DELEGATED OFFICER REPORT

**WOKINGHAM
BOROUGH COUNCIL**

Application Number:	252221
Site Address:	134 Victoria Road, Wargrave, Wokingham, RG10 8AJ
Expiry Date:	20 November 2025
Site Visit Date:	6 October 2025
Proposal: Householder application for the proposed erection of a single storey side / rear extension, erection of 1no. Rear dormer to the rear loft elevation plus changes to fenestration to include relocation of existing rooflight.

Figure 1: 3D elevations provided by the applicant within this submission and 252221.

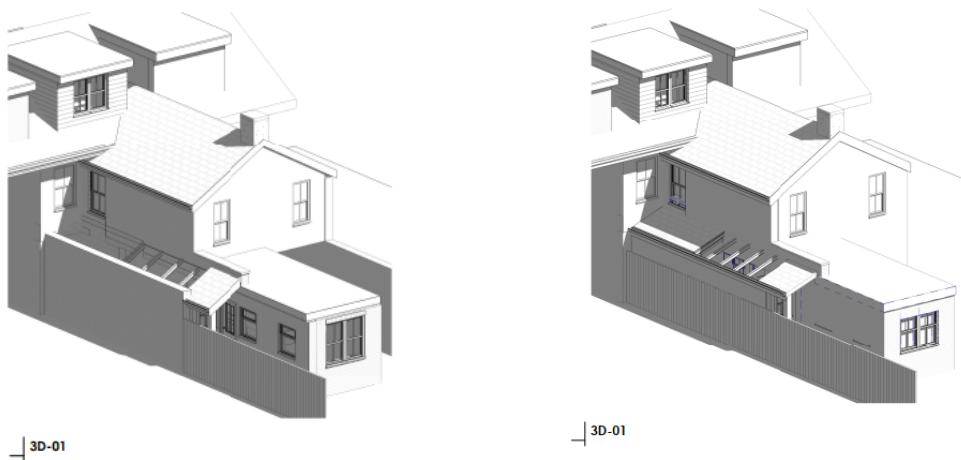
A non-material amendment to planning consent 242550 was submitted for repositioning the proposed side / boundary wall of the rear extension and increasing the height of the proposed parapet wall to 3m. This application was refused as the changes proposed were material and required further assessment through a planning application.
No works referring to this application have started as application 252221 sought to supersede them to create an amended rear elevation. The minor changes between extant 252221 and the current proposal are shown below, in 3D elevations provided by the applicant:

It is noted that following officer concerns raised in relation to an initially proposed parapet wall directly on the site's boundary, revised plans were submitted on 14/11/2025. This alleviated the concerns raised by officers with respect to loss of light and overbearing. Considering the nature of the amendment, a full re-consultation was not required in this instance.
